# UNITED STATES PATENT AND TRADEMARK OFFICE

APPLICATION NO.	FILING DATE	FIRST NAMED INVENTOR	ATTORNEY DOCKET NO.	CONFIRMATION NO.
10/823,878	04/14/2004	Joseph Vogrig	78592	5675

## Office Action Summary

## DETAILED ACTION

Fig 9, Musil US Pub 2004/0045136.

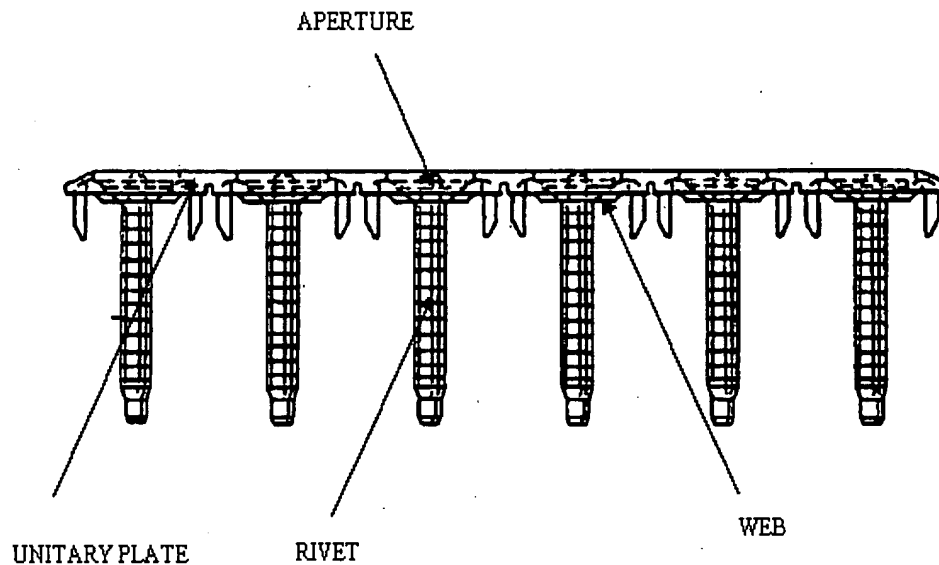
With respect to claim 1, Musil Fig 2 and Fig 9 discloses a unitary plate body of a predetermined thickness and having an upper surface and a lower surface spaced by the predetermined thickness of the body; a plurality of rivets having preformed rivet heads including top surfaces that are aligned with each other; a plurality of apertures of the unitary plate configured to support the rivets depending from the plate so that the top surfaces of the rivet heads do not project above the upper surface of the plate body, and the rivet head top surfaces are closer to the lower surface than the upper surface of the plate body.

With respect to claim 2, Musil discloses that the plate predetermined thickness is sized to receive the preformed heads of the rivets (Fig 9).

With respect to claim 6, Musil discloses that the plate includes portions above and generally below the heads of the rivets in the apertures to capture the heads therein (Fig 9).
